GERALD R. FORD INTERNATIONAL AIRPORT

**TAXIWAY F & G RECONSTRUCTION (NORTH OF TAXIWAY V, 1,950' X 35');
TAXIWAY F & G AIRFIELD LIGHTING REPLACEMENT**

PROJECT NUMBER C-435

ADDENDUM #2

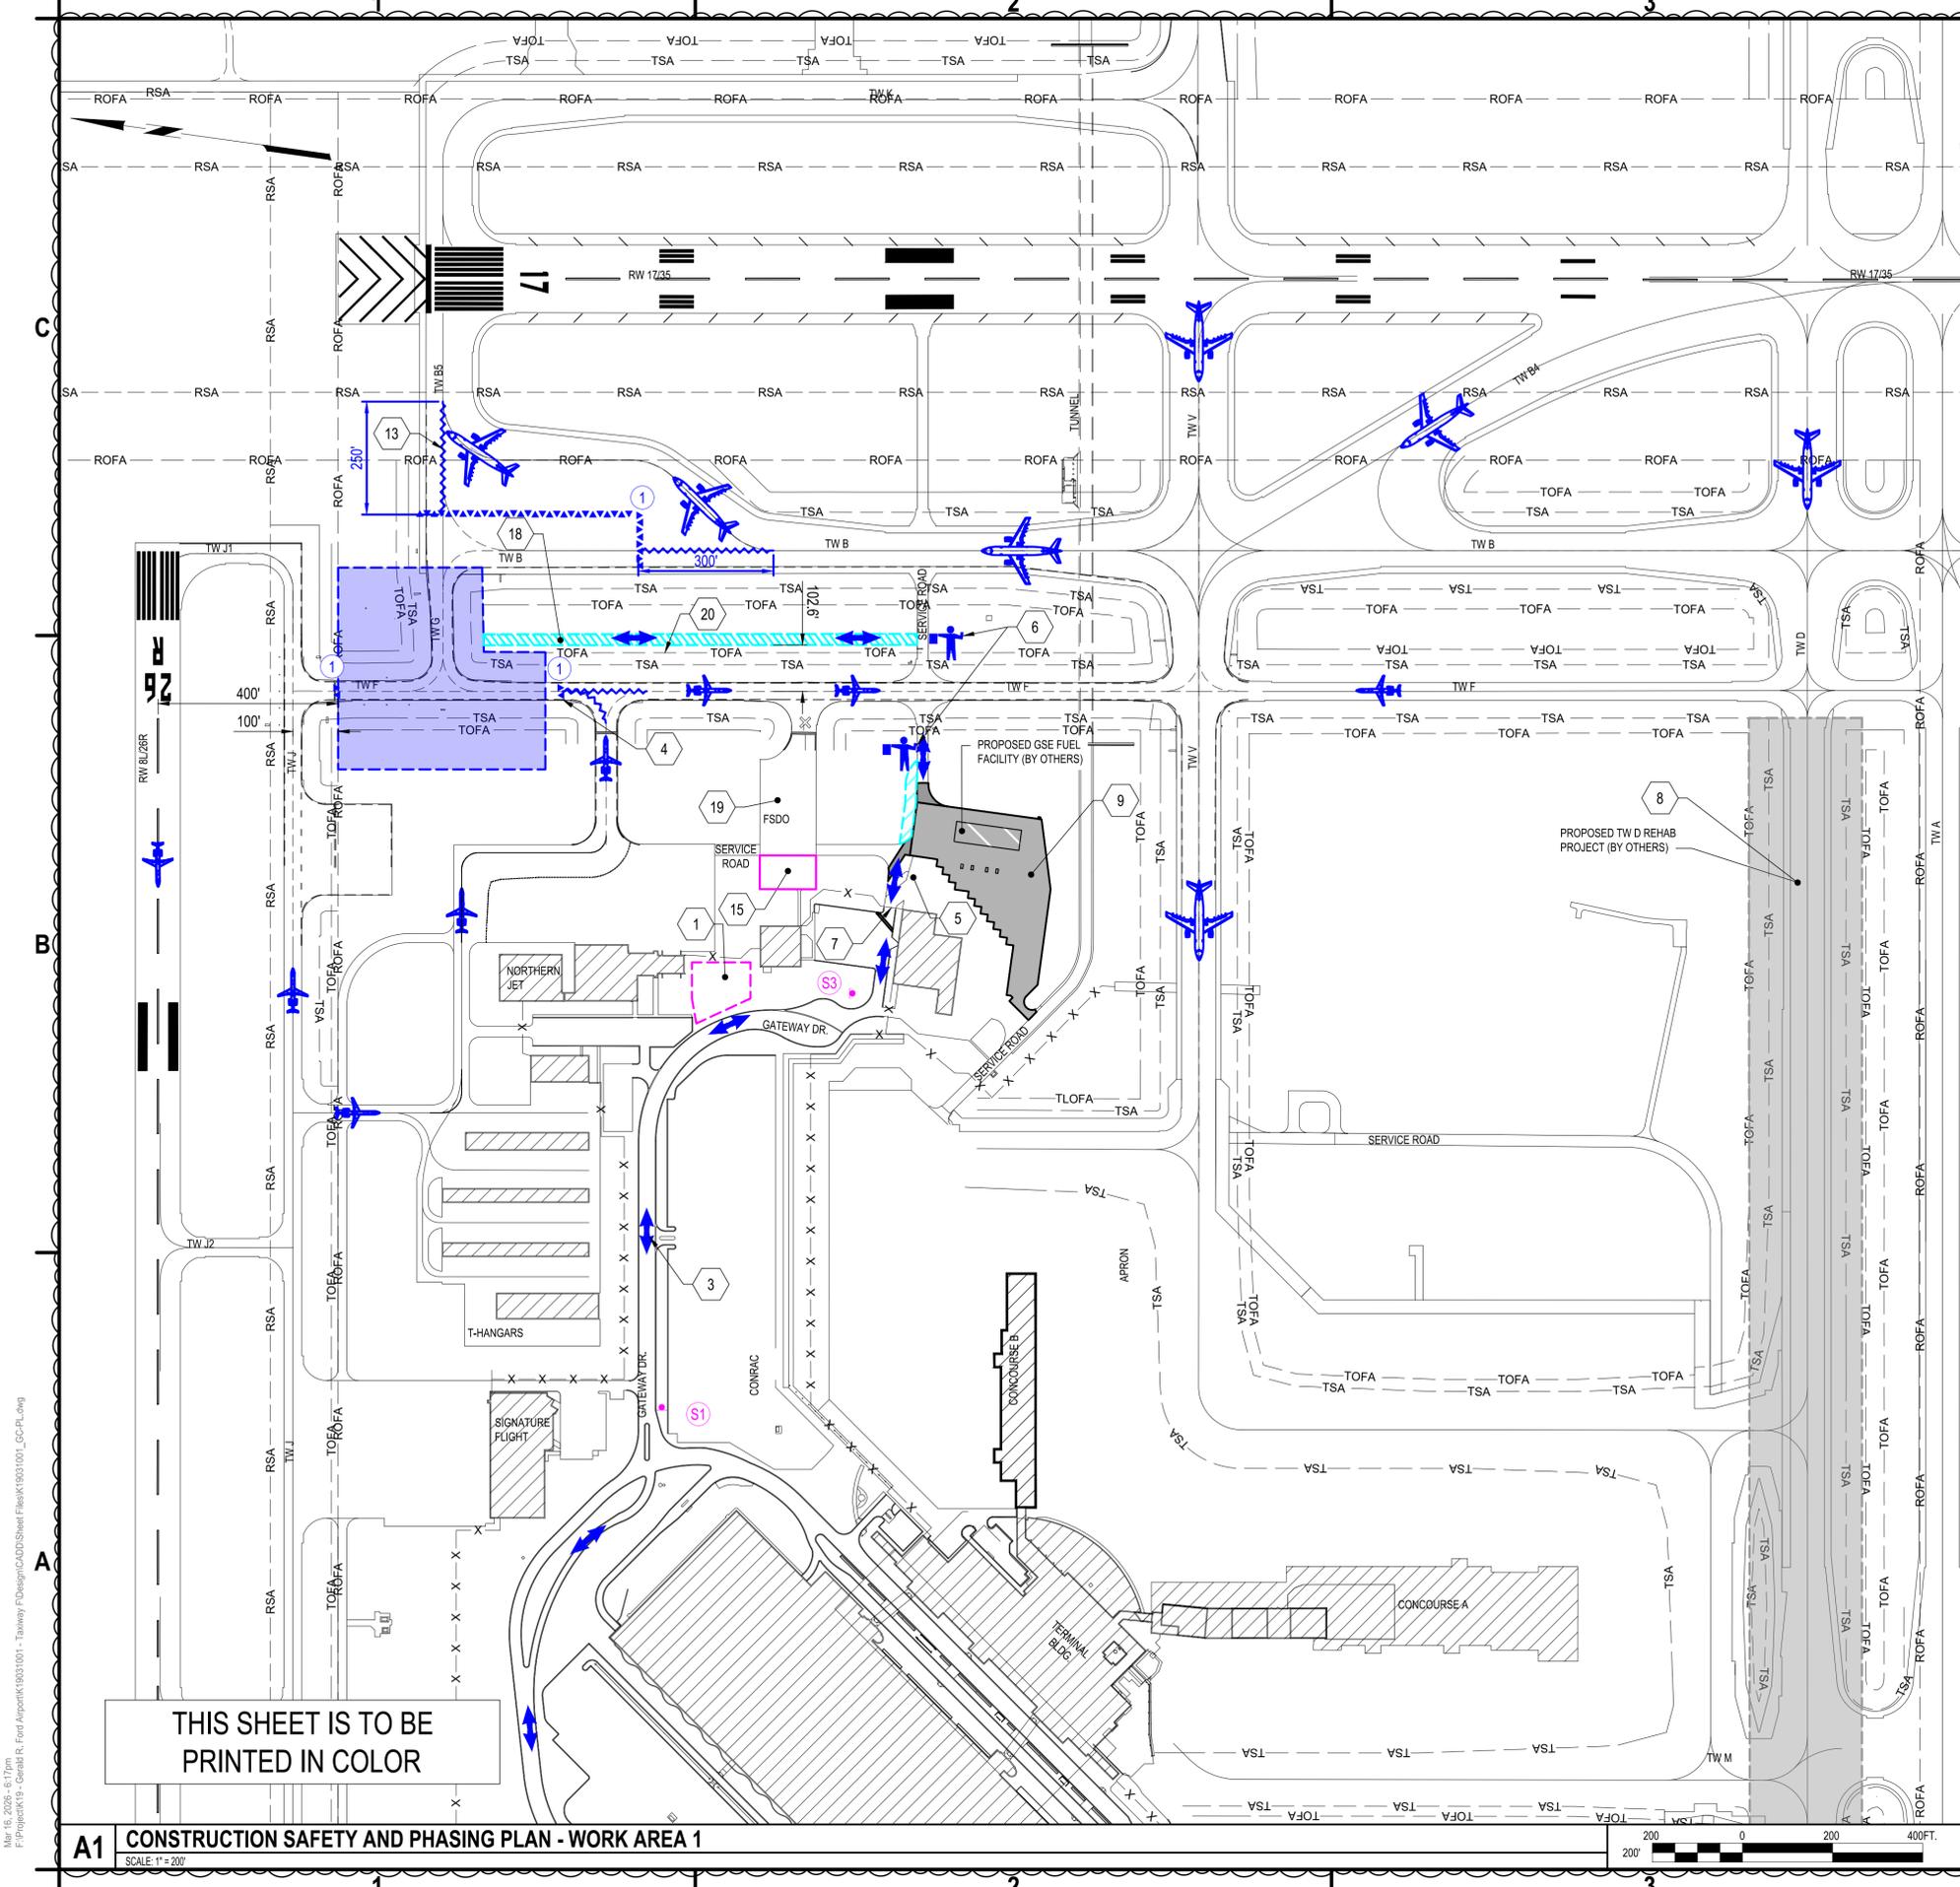
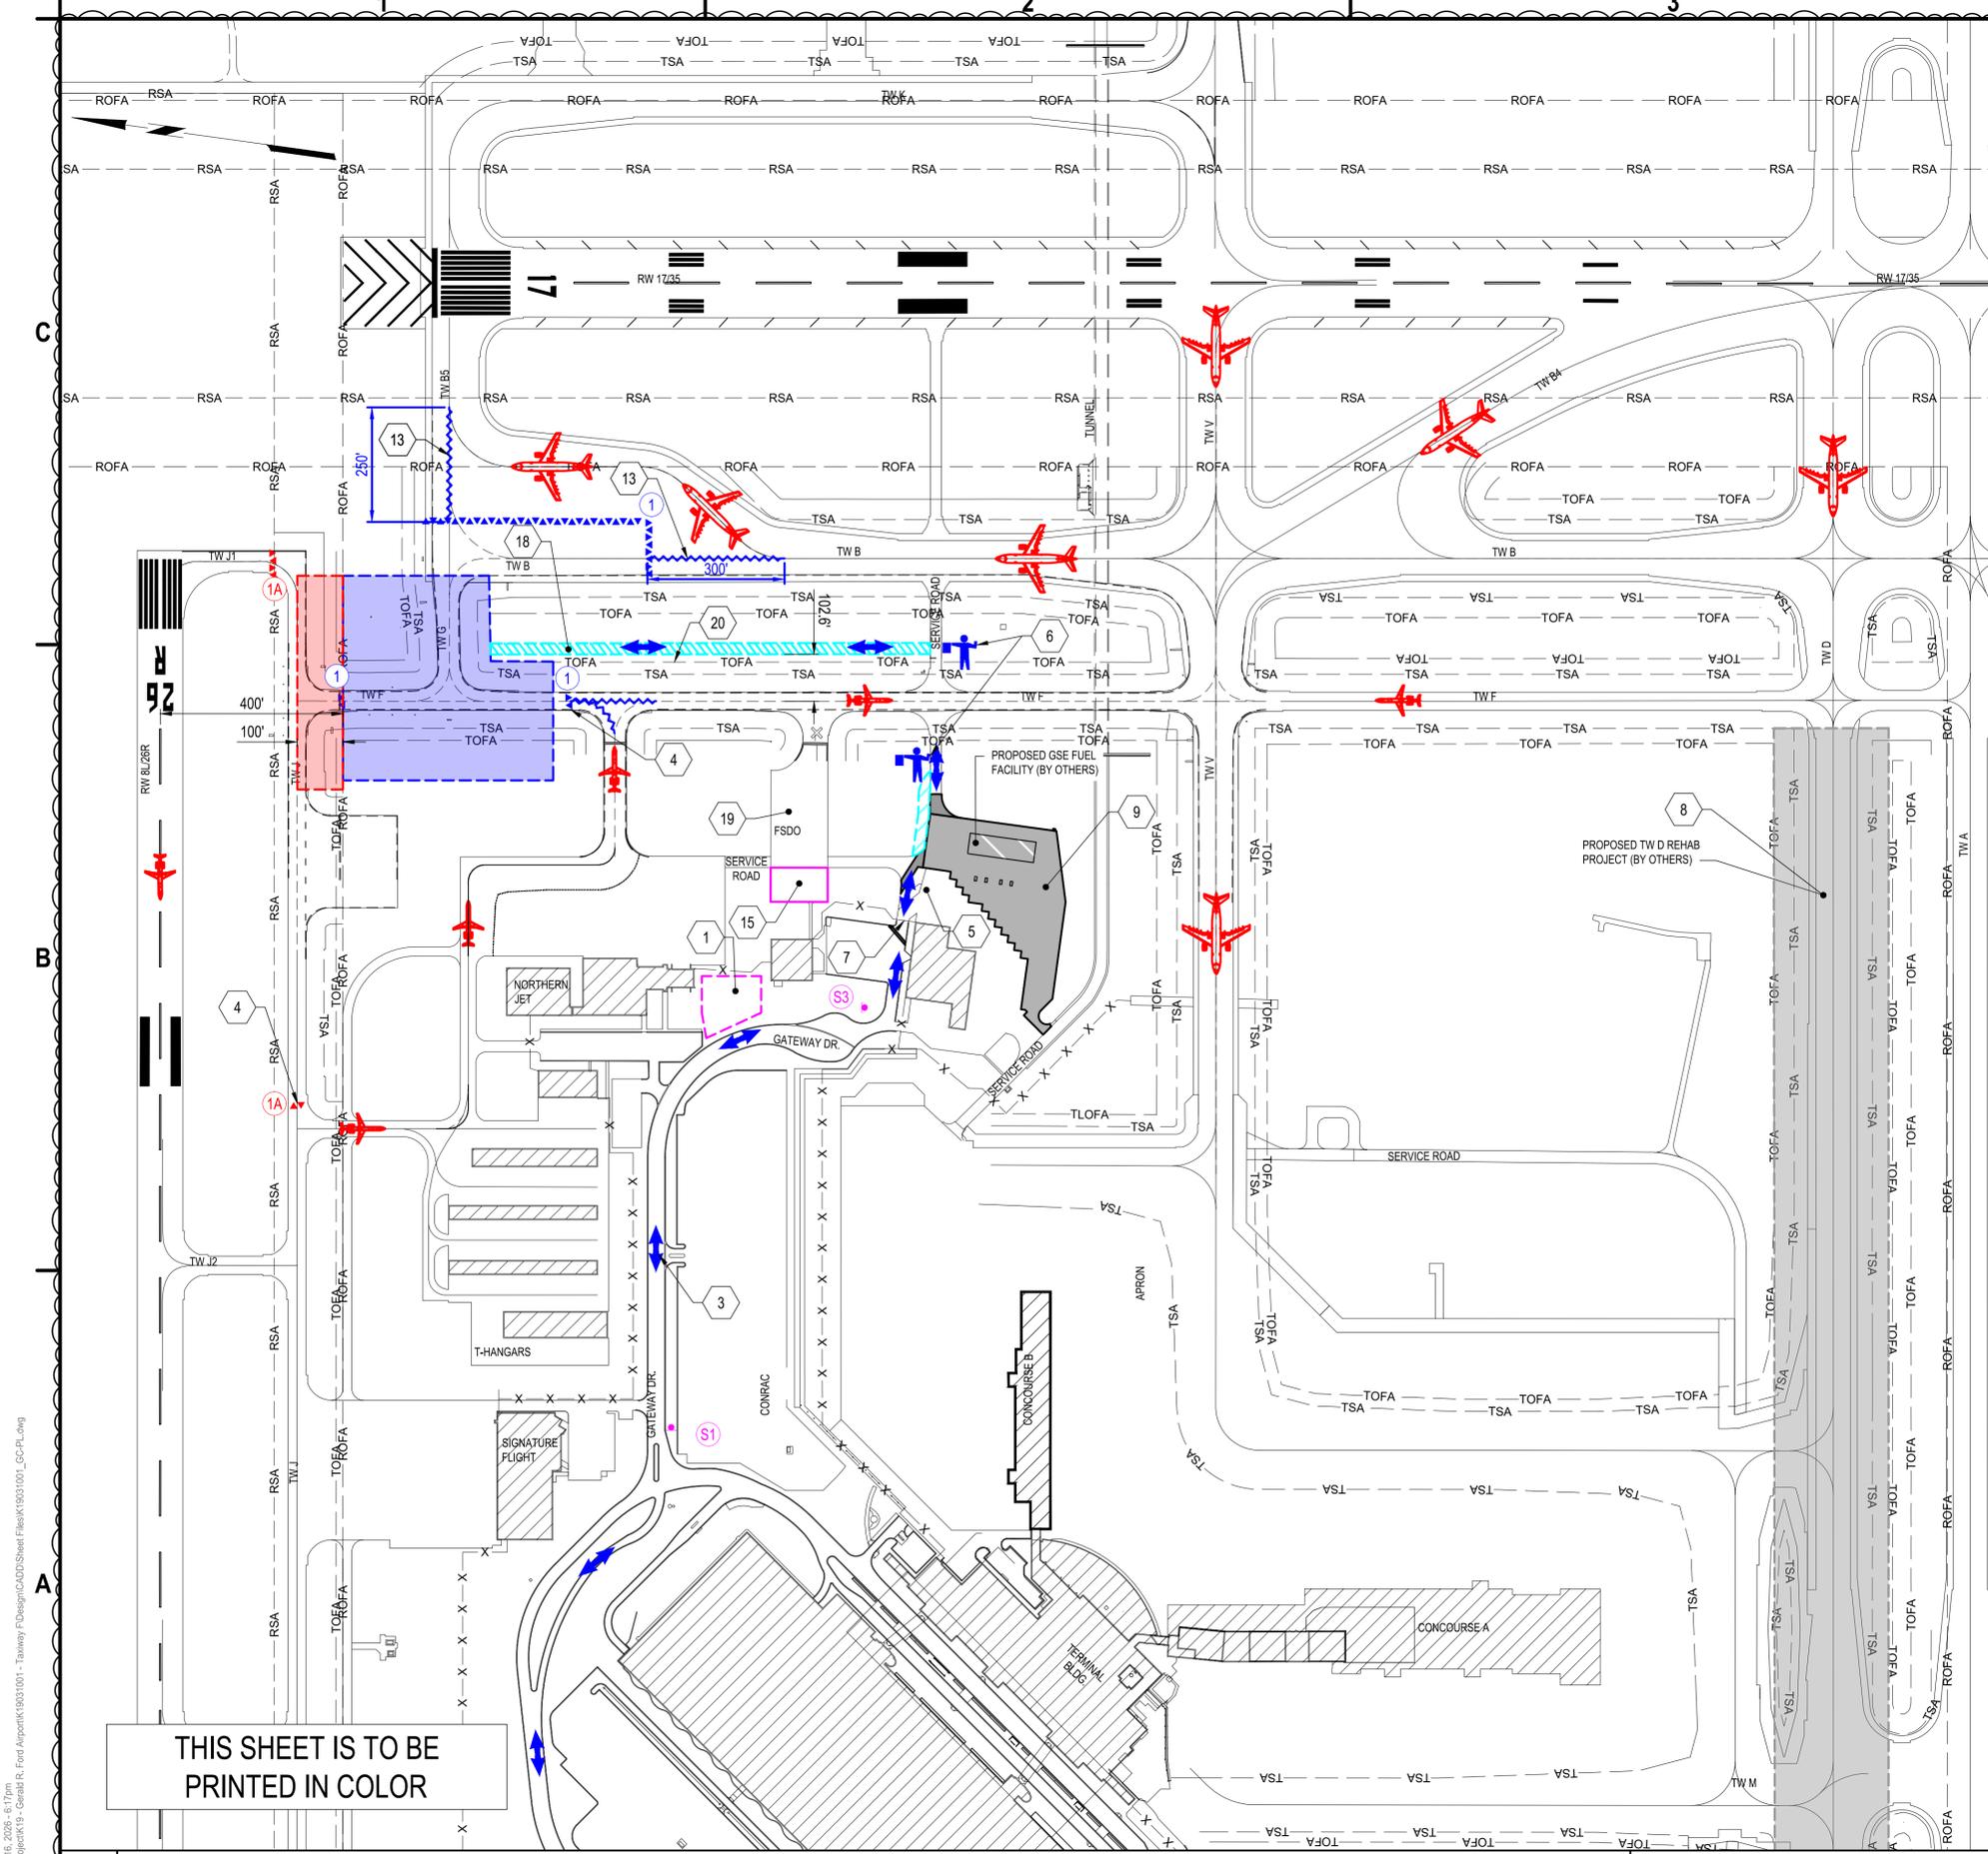
- Q: My main questions concern note no. 20 on pages GC102 thru GC105. The note states to “place low profile barricades in turf along TOFA”. Are these being interlocked for that area as well?
- A: The barricades to be used to line the TOFA in the turf along the gravel haul road may be spaced 10’ apart.
- Q: Sheet GC105: It has the note in the key notes but doesn’t show any no. 20’s (do you need barricades on the TOFA line on this page (which this one would actually be a much longer area along the TOFA – or don’t you need these because the haul road is no longer being utilized there)?
- A: No lining of the TOFA is needed in this phase. Keyed note 20 will be deleted from this sheet.
